RENESAS TECHNICAL UPDATE

Product Category	MPU/MCU		Document No.	TN-SH7-A799A/E	Rev.	1.00
Title	Usage note on Serial Sound Interface		Information Category	Technical Notification		
Applicable Product	SH7262 Group SH7264 Group SH7266 Group SH7267 Group	Lot No.	Reference Document	 SH7262 Group, SH7264 Group Hardware Manual Rev.2.00 (REJ09B0445-0200) SH7266 Group, SH7267 Group Hardware Manual Rev.1.00 (REJ09B0566-0100)

Figure 1 Transmission Using Direct Memory Access Controller

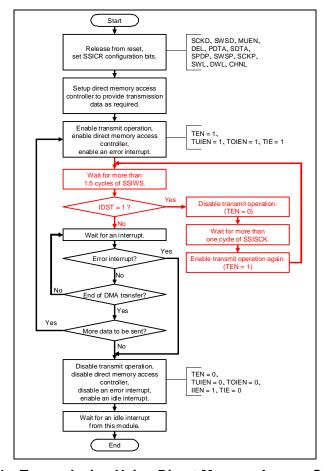
Transmit operation may not be started, even though the TEN bit in Control register (SSICR) is set to 1.

To start transmit operation, please follow the procedure in figure 1 or figure 2 below.
